SERVICE BULLETIN

APPLICABILITY: 2022-24MY WRX

NUMBER: 05-93-26

SUBJECT: Rubbing Sound from Front Coil Spring

DESCRIPTION OF DESIGN CHANGE:

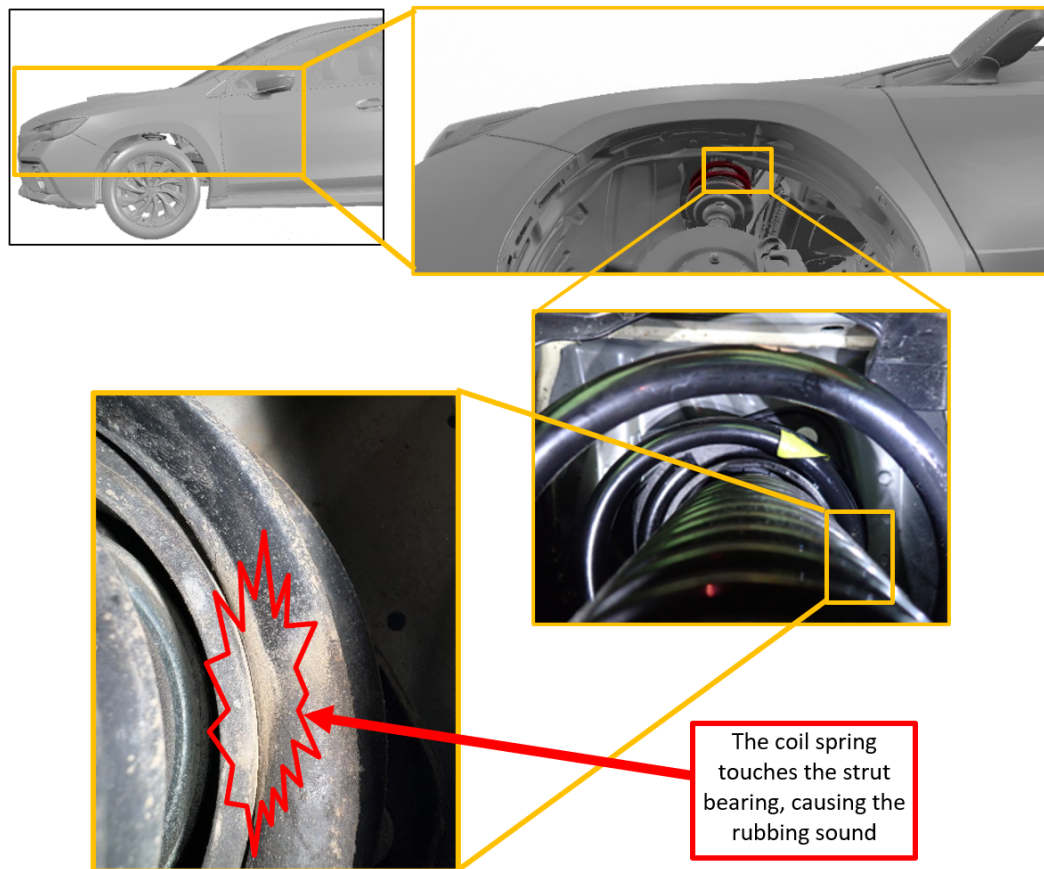
This bulletin announces the design change made to the front coil spring to address cases of a rubbing sound heard driving over bumps and/or turning. This sound is caused by contact between the coil spring and the strut bearing. The new springs have a reshaped coil to allow more strut bearing clearance further reducing any spring/bearing contact. If a rubbing sound is duplicated from the front coil spring(s), both springs will require replacement.

Old	New	Identification paint																				
Rear Front Inside Outside	Rear Front Inside Outside Changed the number of turns. (+0.1)
